WATER LICENCE INSPECTION FORM

City of Iqaluit				M Karveli	and P	MacN	/lunn		
Licence No. / Expiry				Representative	's Title				
3AM-IQA1626				NA					
Land / Other Authorization	18			Land / Other A	uthoriza	itions			
NA									
Date of Inspection				Inspector					
June 4, 2018				Jonathan I	Vlesh	<u>er</u>			
Activities Inspected Camp Roads/Hauling	☐ Drilling ☐ Other: Mu	unicipal	☐ Mining	Constru	uction		Reclamation	☐ Fuel S	torage
Conditions: A -	Acceptable		C - Concern	U - Unacceptab			Not Applicable	NI – No	t Inspected
Water Use	Condition	Comment	Site Condition	S	Condit ion	Comme nt	Haz/Mat Manage	ment con	dition Comment
Intake/Screen	Α		Water Manage	ement Structures	U	4	Storage	U	
Flow Measure. Device	e A		Culverts / Brid	ges	С	4	Spills	NI	
Source:	С		Drainage		U	4	Spill Plan	U	
Water Use:	С	3	Erosion / Sedir	ment	U	4,5			
Recirculation (y /n)	N		Mitigation Me	asures	Α		Administrative		
			Reclamation A	ctivities	Α		Records	С

Photo Log #	Location City of Iqaluit
Photo 2

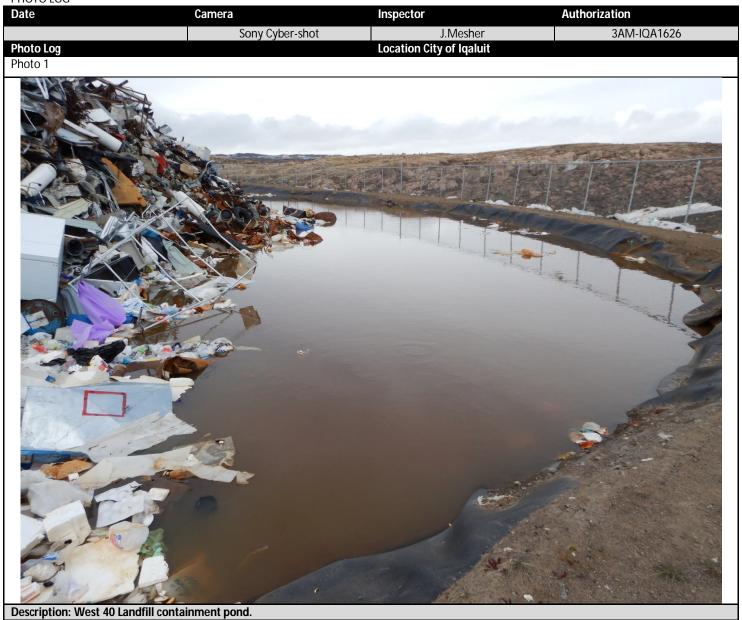
- 11. During the inspection at the West 40 Landfill southeast containment ponds, there were signs of tears, rips and signs of a high water mark leading the inspector to believe that this facilities ability to contain leachate is jeopardized. Due to the poor condition of the containment ponds the inspector is requesting that the licensee conduct a study to ensure that the containment ponds are operating as intended, If the containment ponds are found to be jeopardized the licensee is to follow the conditions in PART G: Conditions Applying to Modifications.

Photo Log #	Location: City of Iqaluit
Photo 4	N W

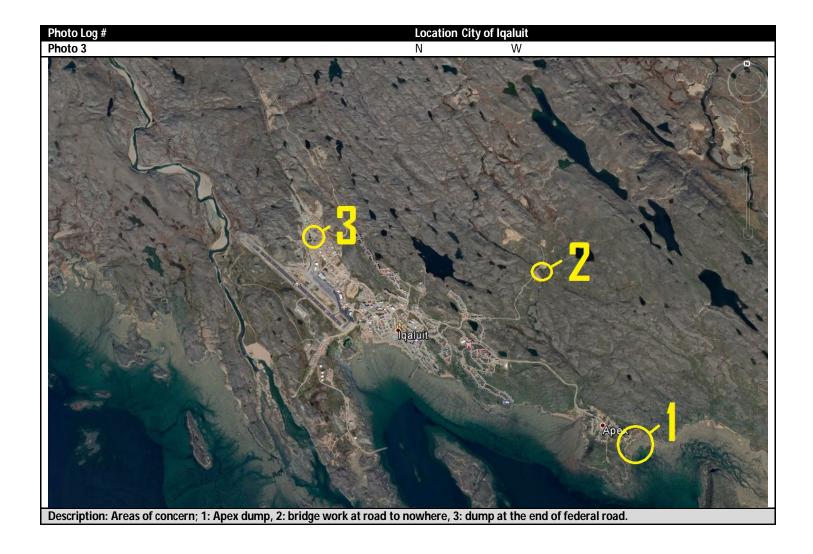
- 8. In the document "The City of Iqaluit City of Iqaluit Landfill Operations and Maintenance Manual, Date: January 2014", Appendix E 2006 Drainage Improvements. It identifies a containment pond on the east side on the facility and one in the center these structures were not in use or visible at the time of the inspection. See photo 4 for the missing ponds.

- I. Please provide the approval provided to remove or modify these waste management structures.
- 9. In the document, "The City of Iqaluit City of Iqaluit Landfill Operations and Maintenance Manual, Date: January 2014", Appendix E 2006 Drainage Improvements, it shows that the surface drainage on the north side of the facility is intended to flow East towards ditches and two containment ponds within the facility. The North end of this facility now slopes west towards an area where no containment ditches are present and flows directly in the surrounding environment. See photo 6 for the landfill sloping to the environment and photo 4 for the intended slope of the landfill.
